To: All RedMax Distributors and Dealers
Subject: EBZ7500, EBZ7500RH, EBZ8500 & EBZ8500RH
Instruction for preventing Crank Case Damage

PRODUCT MODEL	PRODUCT SERIAL NUMBER
EBZ7500 (966 62 43-01)	EBZ7500 : Up to #20799999
EBZ7500RH (966 70 99-01)	EBZ7500RH : Up to #20799999
EBZ8500 (966 62 45-01)	EBZ8500 : Up to #20799999
EBZ8500RH (966 71 00-01)	EBZ8500RH : Up to #20799999

Fig. 1: Retighten 4 bolts in crisscross fashion

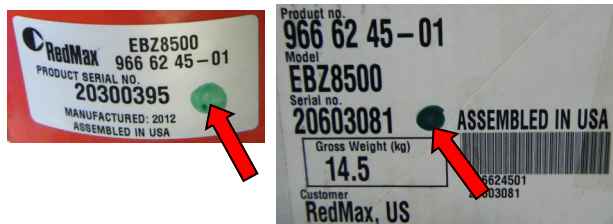
RedMax received field reports that one of the bolts securing engine crank case to fan (volute) case may come loose. The bolt location is in the upper right hand corner on the muffler side of the engine, see Fig. 1 below.

Should you have units in stock with serial number below 20799999, please retighten all 4 bolts in crisscross fashion as specified in Fig.1 using T-27 bit or wrench to tightening torque of 55-65 Inches-lbs. or 4.6 to 5.5 ft.-lbs.
